# SERVICE INSTRUCTION

Service Instruction No. 1577A  
(Supersedes Service Instruction No. 1577)  
Engineering Aspects are FAA Approved

SUBJECT: Intake Valve In-Service Data

MODELS AFFECTED: O-540-F1B5 engines with serial number ending with “-40E” installed in Robinson R44 Raven I and R44 Cadet helicopters

**Figure 1**

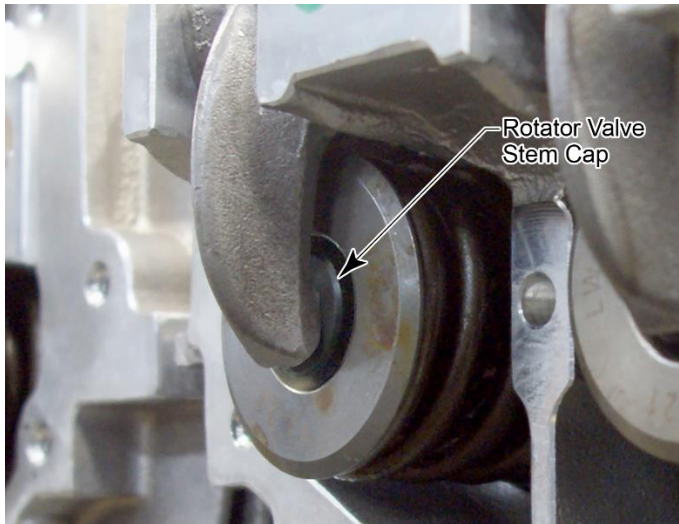
- Remove rocker box covers in accordance with the appropriate maintenance or overhaul manual
- Inspect for the presence of a Rotator Valve Stem Cap (Figure 1 & 2) on the intake valves
- Cork rocker box cover gaskets (PN 75906) are to be replaced. Silicone rocker box gaskets (PN 06B26669) can be inspected and reused if not damaged, replace damaged silicone rocker box gaskets as necessary
- Reinstall the rocker box covers in accordance with the appropriate maintenance or overhaul manual. Refer to the latest revision of SSP-1776 for rocker box screw torque values for cork or silicone gaskets
